TECHNICAL SERVICE BULLETIN

CAMON C2000 Tiller

Guide to Start Levers

C2000 On/Off Switch & Throttle Lever

Figure 3

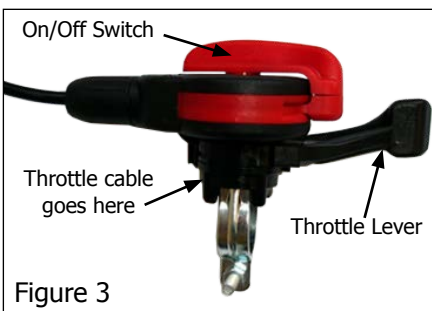
The following throttle and on/off switch have been replaced:

The new Start lever combines the on/off switch and throttle lever into a single part:

The new Throttle and Switch can be used on older C2000 handlebars.

Figure 5

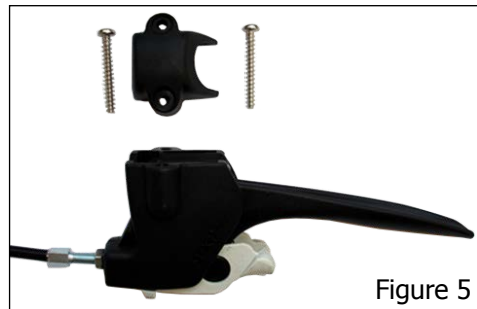
The new Start levers cannot be attached to older C2000 handlebars that have the welded control lever bracket attached.

The welded metal control lever has been replaced by a bolt-on plastic control lever:
